PLANNING COMMISSION AGENDA

- 6) **PUBLIC HEARINGS & SUBSEQUENT BOARD ACTION**
 - A. SPLU26-0001 - 902/1102 West Hanover Street Special Land Use
- 7) **OLD BUSINESS**
- 8) **REPORTS AND RECOMMENDATIONS/NEW BUSINESS**

- A. SP# 23.04- 902/1102 West Hanover Street Site Plan
- 9) **PUBLIC COMMENT ON NON-AGENDA ITEMS** Persons addressing the board are required to give their name and address for the record when called upon by the Chair. Members of the public shall be limited to speaking for a maximum of three (3) minutes. Comments should address NON-AGENDA ITEM topics. Public Hearing items should be addressed during the PUBLIC HEARING portion of the meeting agenda. Agenda items should be addressed during the PUBLIC COMMENT-AGENDA ITEMS portion of the meeting agenda.

TO: HONORABLE COMMISSION MEMBERS
FROM: Marcia Strange, Director of Community Development
DATE: June 10, 2026
SUBJECT: SP# 23.04- 902/1102 West Hanover Street Site Plan

TEMPORARY SITE LAYOUT PLAN - SLU
HANOVER STREET STORAGE
SUNDANCER, LLC

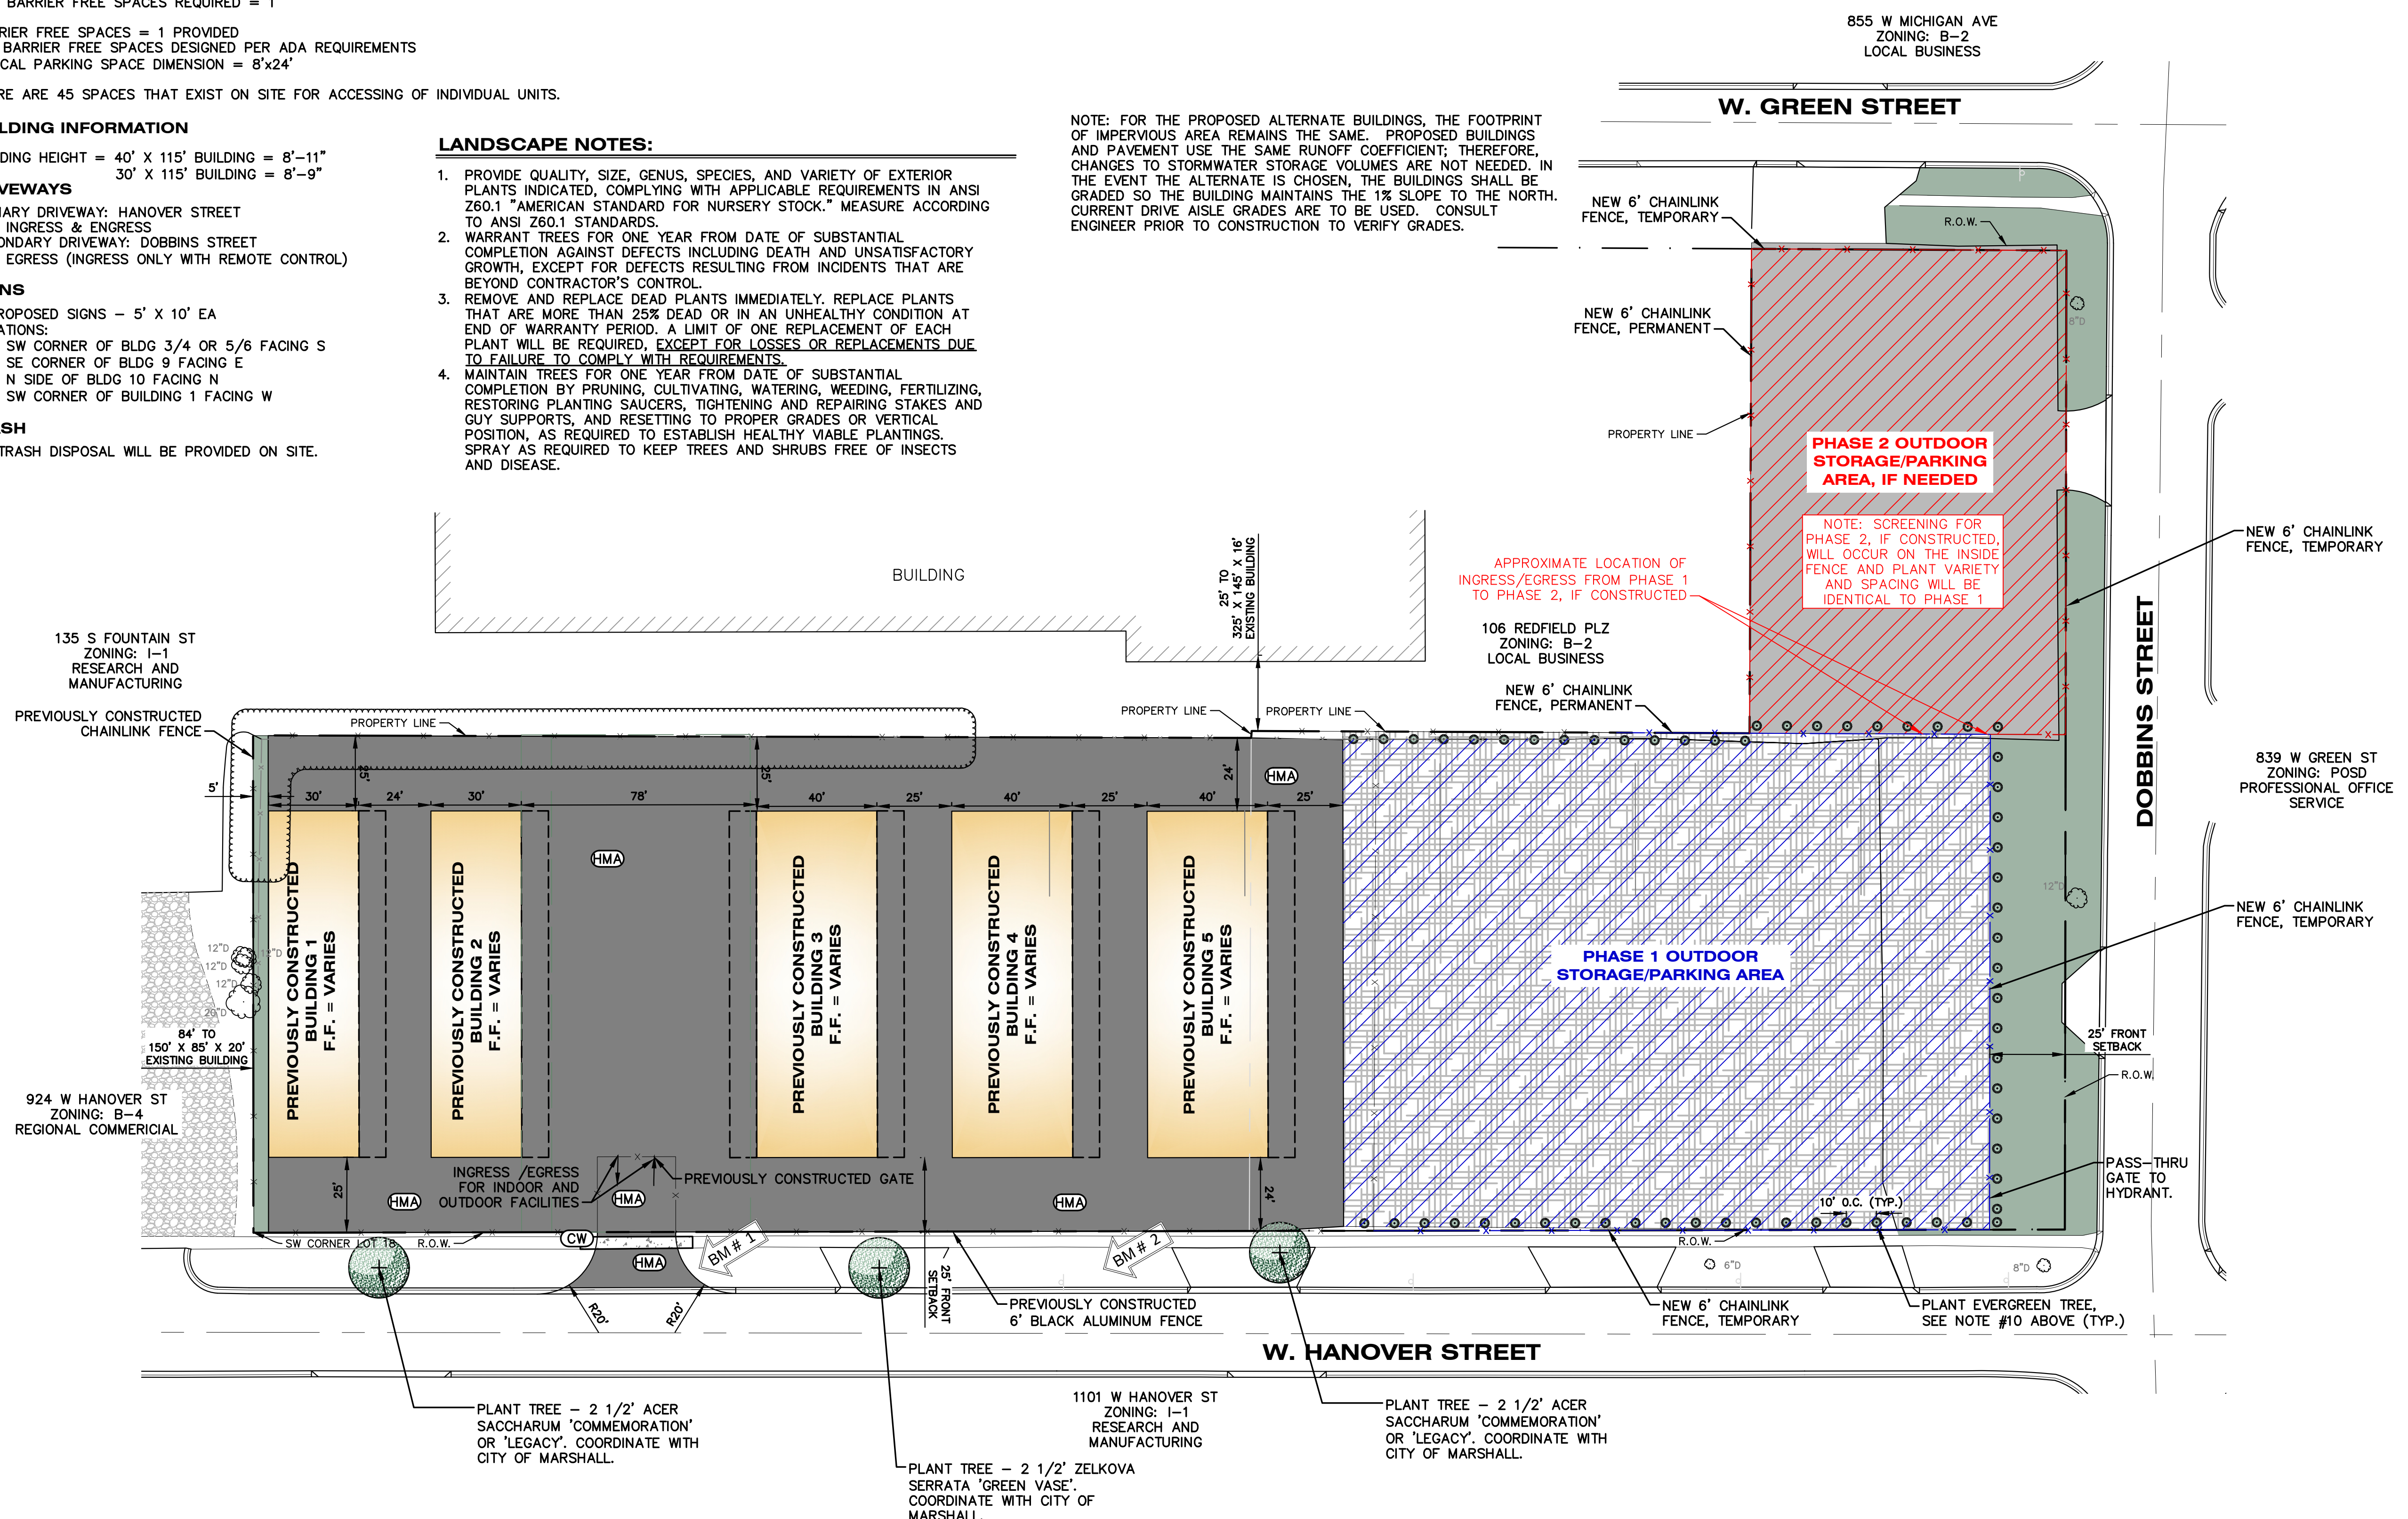
City staff have been working with the property owners, Adam and Kelly Rickert, and their engineer, Hurley & Stewart, on this project which would see the addition of outdoor storage to their self-storage facility at 902 and 1102 West Hanover Street. The parcel has been built-out with five of the buildings planned. The owners have proposed a revision to their approved site plan that allows for use of the remaining space as outdoor storage until the company has enough funds to build the remaining self-storage buildings. The owners have proposed an outdoor storage area which is fully enclosed by chain link fence and screened with evergreens per our screening requirements. The sidewalk and street trees that were required on the original site plan should be maintained as a requirement. but are not shown on the new submittal.

Existing black aluminum fencing on the Hanover, and Green frontages and chain link between Redfield Plaza and the site remain. The addition of outdoor storage requires screening to all adjacent right-of-way and other uses. Trees will need to be planted within the ROW. Original design of sidewalk and tree planting would be acceptable

Approve Revised Site Plan SP# 23.04 with the following conditions: street trees would need to be planted along Dobbins with locations approved by City staff, and sidewalk to be installed within the next five years. The exterior lighting should be adjusted with shielding in place to ensure compliance with the ordinance. Revised photometric can be reviewed by the Zoning Administrator for confirmation.

PHOTOMETRIC PLAN - SLU
HANOVER STREET STORAGE
SUNDANCER, LLC

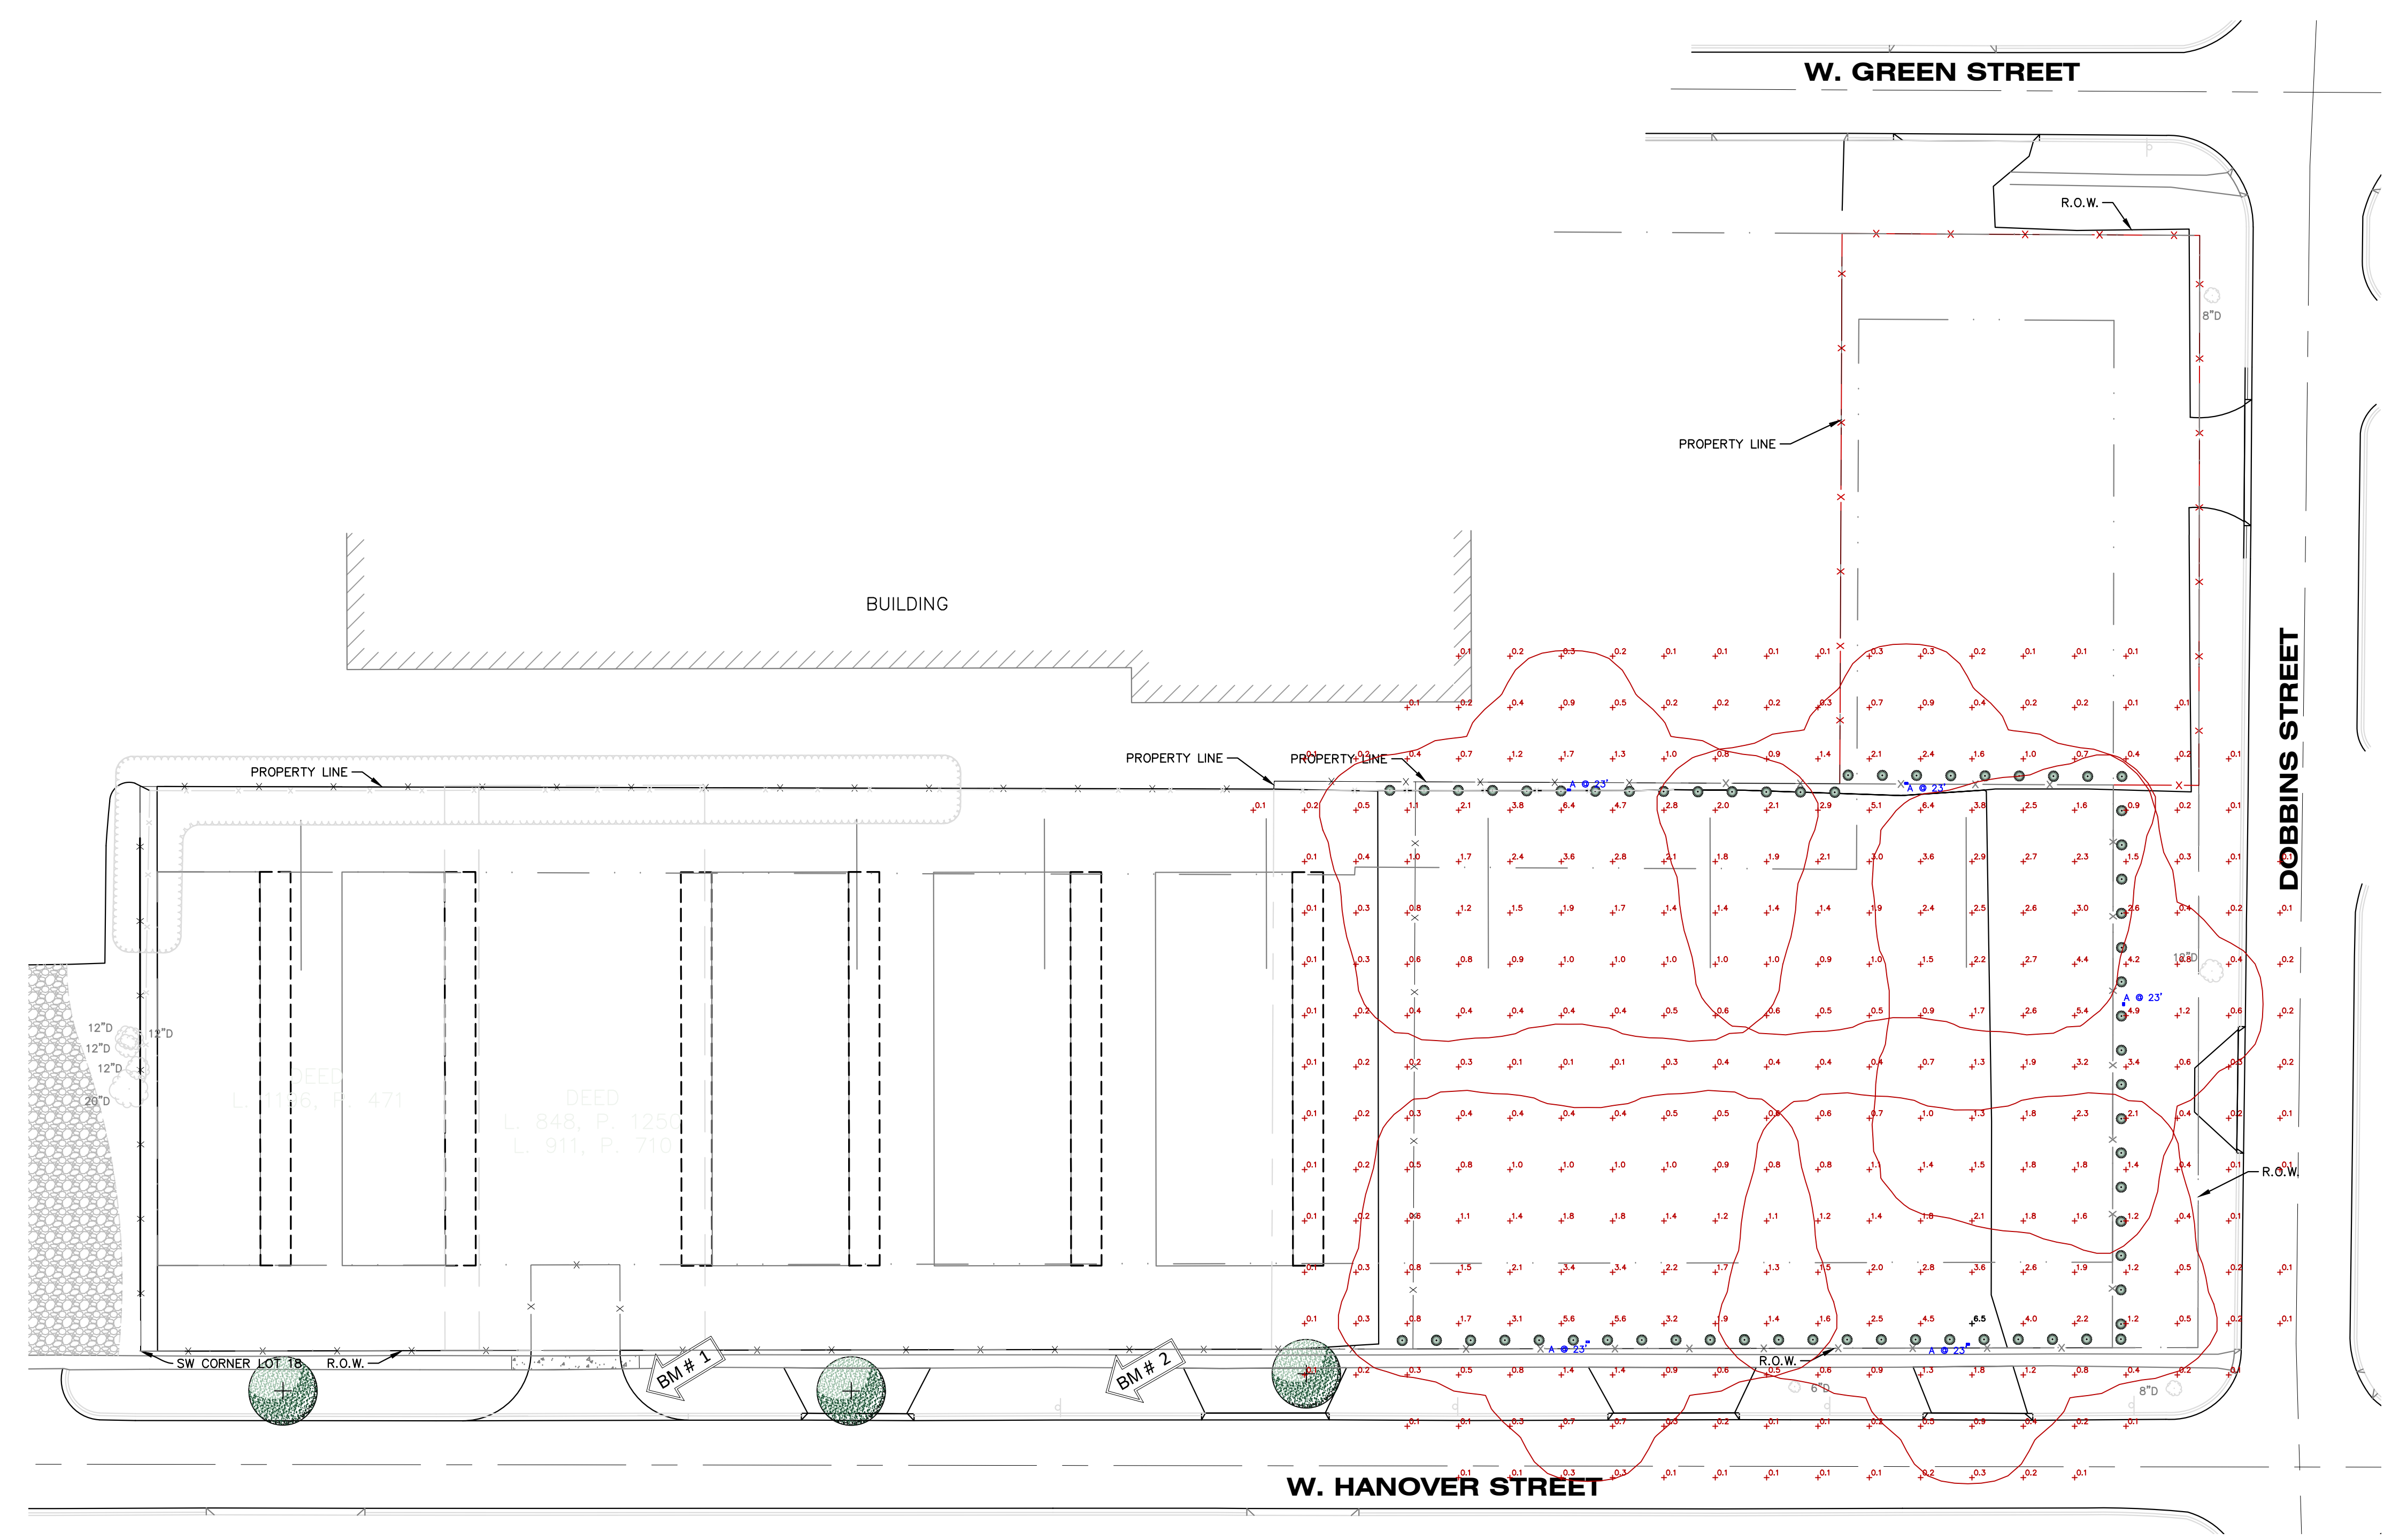
The required photometric plan was included with the submitted plans showing compliance at property line in most locations. The western light on the north side has slight light trespass onto the parking lot of the adjacent Redfield Plaza. It is not anticipated this will be problematic at this location as the light level falls off quickly, however additional shielding could be required to meet the ordinance.

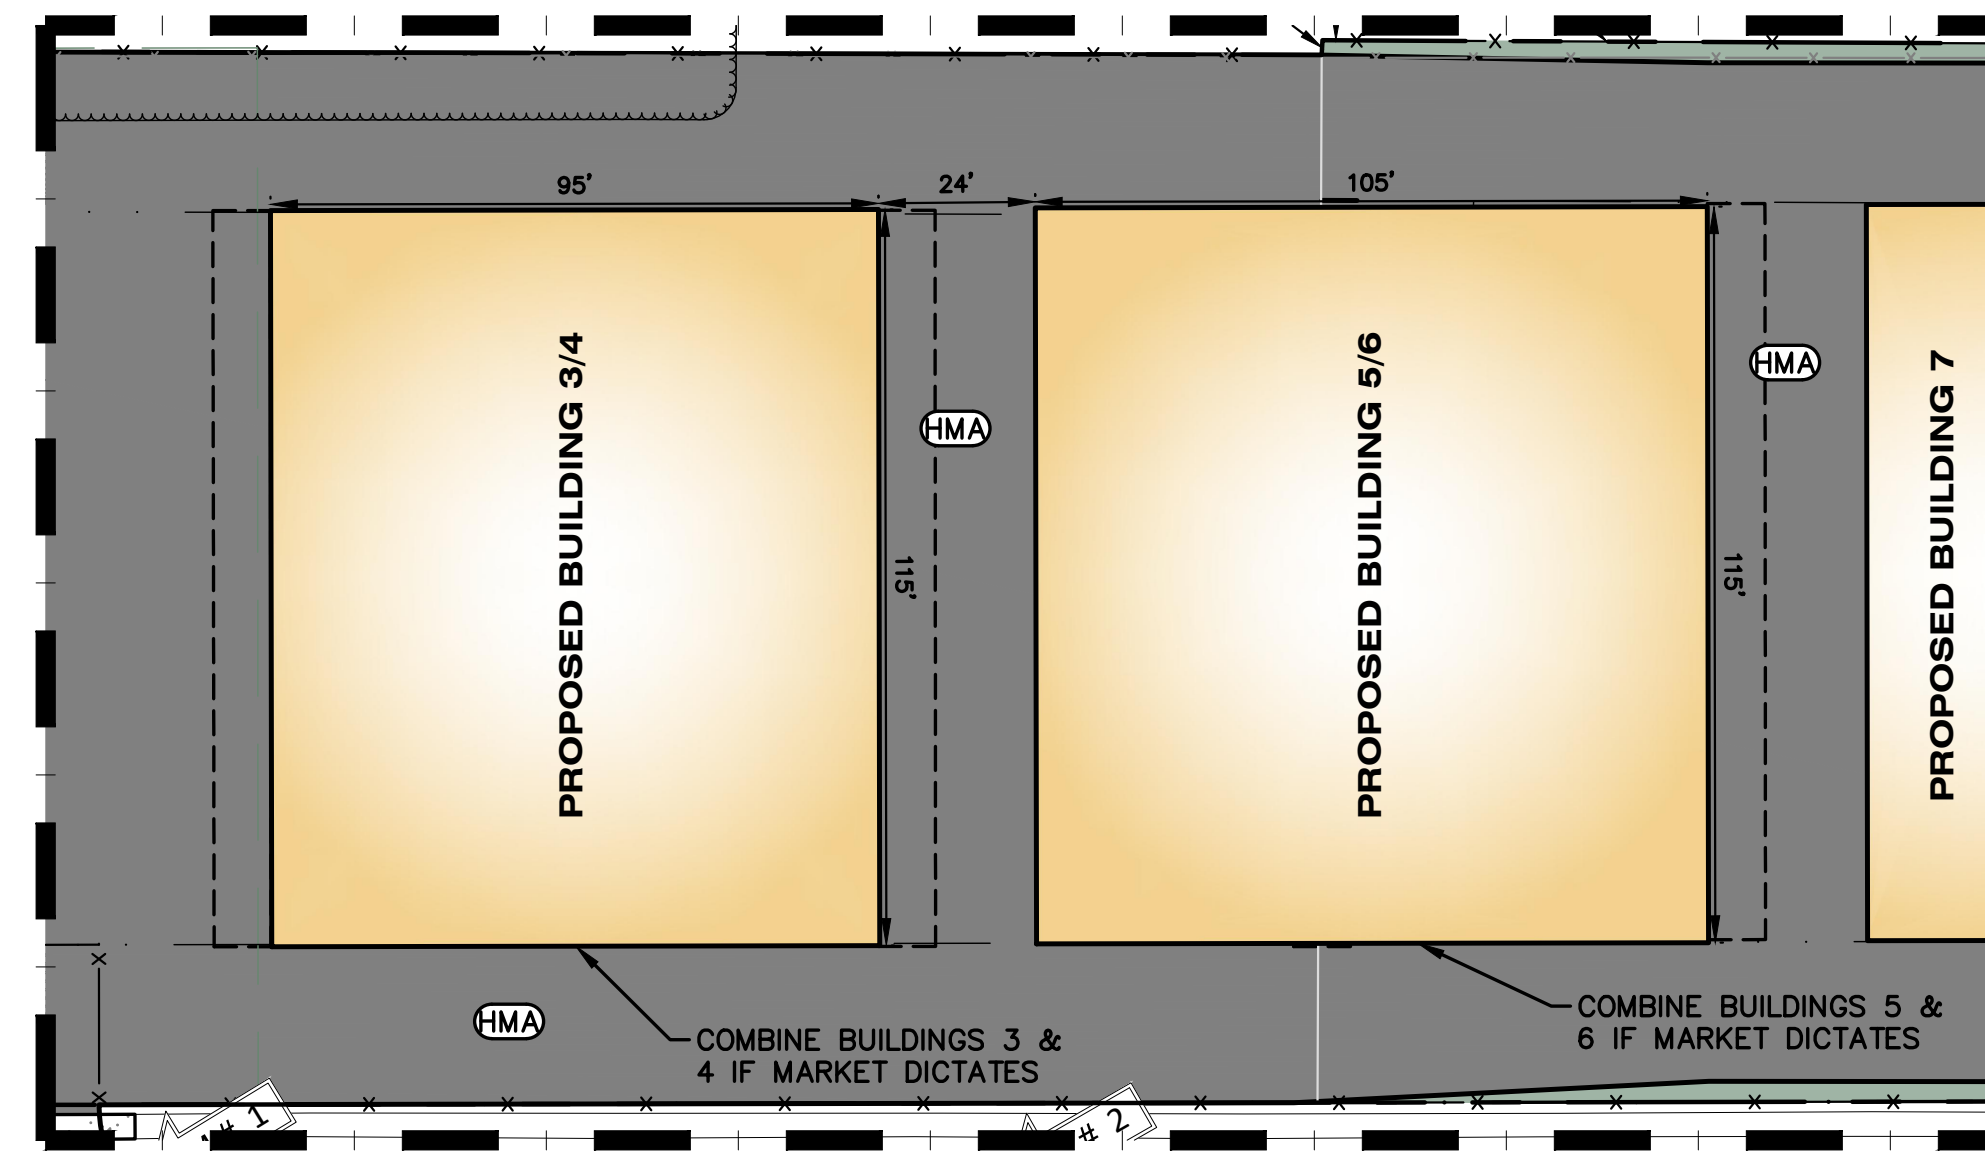
2. Please provide a chart of impervious area on C-2 by building and HMA area to tie back to impervious area in stormwater calcs. Need separated by proposed watersheds.

Response: Acknowledged. We have specified the tree types on sheet C-2 and specified the requirement to coordinate with the city regarding these utilities.

Response: This note was added to sheet C-2.
14. Landscaping requirements from the ordinance are as follows:
 Interior Landscaping. For every new development, except single-family detached dwellings and any use in the MHPD (Manufactured Housing Park) district or B-3 (Neighborhood Business) district, interior landscaping areas exclusive of any other required landscaping shall be provided, consisting of at least 5% of the total lot area. This landscaped area should be grouped near building entrances, along building foundations, along pedestrian walkways, and along service areas. All interior landscaping shall conform to the following:

Response: This chart has been provided on sheet C-2.

Response: This statement has been added to sheet C-2.

Response: The pass-thru gate has been added to the southeast corner of the site, and is annotated on sheet C-2.
